BX Aviation

Cherry BX-2 Supplement # 4

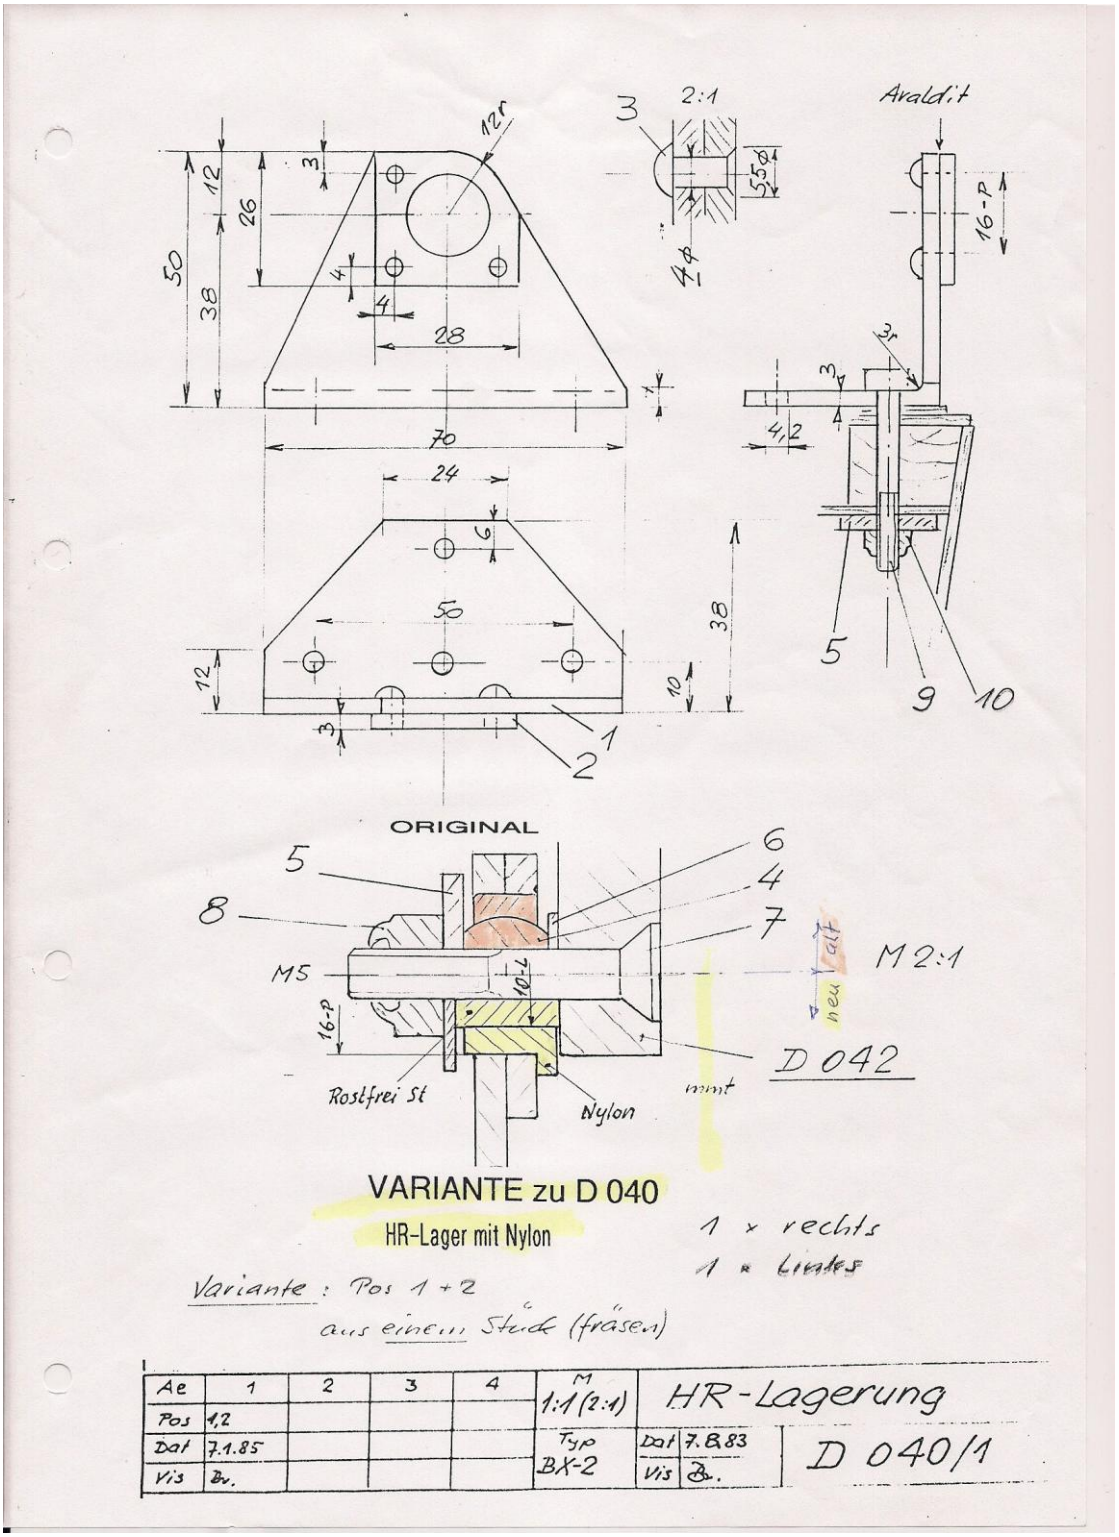
Vertical stabilizer bearing: Worn out bearings can be replaced (according to the sketch “neu” = new) by simple Nylon (PA)-bearings (D 040/1)
